UNITED STATES PATENT AND TRADEMARK OFFICE

APPLICATION NO.	FILING DATE	FIRST NAMED INVENTOR	ATTORNEY DOCKET NO.	CONFIRMATION NO.
10/763,713	01/23/2004	L. Steven Cline	60,130-1817/03MRA0145	7324

Office Action Summary

DETAILED ACTION

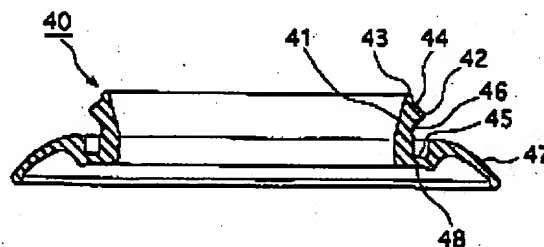
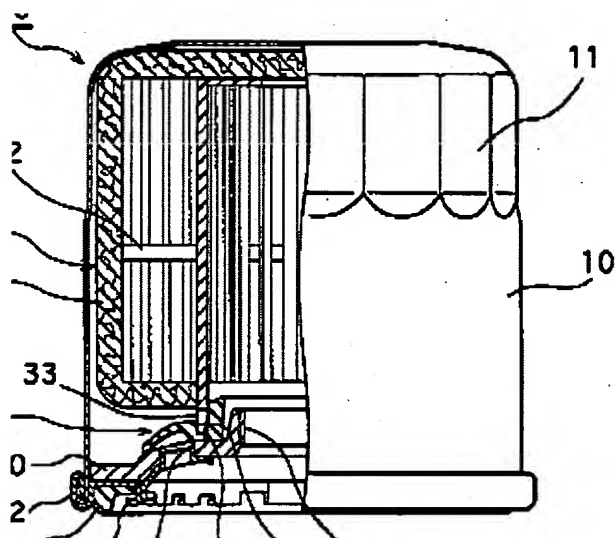
8. Claims 1-7 and 9-15 are rejected under 35 U.S.C. 102(b) as being clearly anticipated by Suzuki et al. (U.S. 6,136,183). As shown by his drawings, Suzuki teaches a fluid filter and valve combination, wherein the valve includes an elastomeric annular relief valve 41 and an anti-

plate includes a threaded portion 22 [as in claims 1-7 and 9-15].

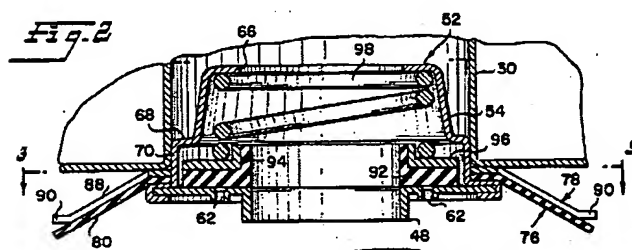
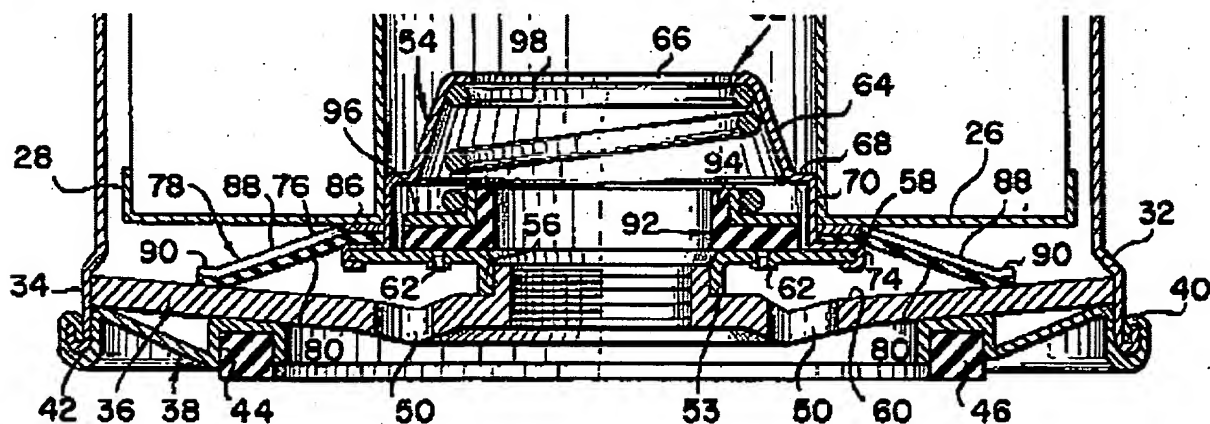
9. Claims 1 and 8 are rejected under 35 U.S.C. 102(b) as being anticipated by Hultgren (U.S. 3,473,664). Hultgren teaches a filter and valve combination wherein the filter includes a housing 12 and end "portion" 36 with apertures 50. A center portion (64+68+70+74+58) is arranged in the housing proximate the end portion and includes a "second" aperture 62. A "valve assembly" (92+94+96+98) is captured by the center portion and also the end portion (since 36 supports 56 of the center portion which supports 92 enabling the valve assembly to be "captured"). The relief valve 92 is considered to be flexible because of the spring 98 which allows movement (a flexibility of position). Because of vertical portion 94, the valve extends "longitudinally" [as in claim 1]. An anti-drainback valve includes an elastomeric portion that

is captured between the center portion (adjacent 74) and an end disk (either end cap 26 or the leaf spring) [as in claim 8].
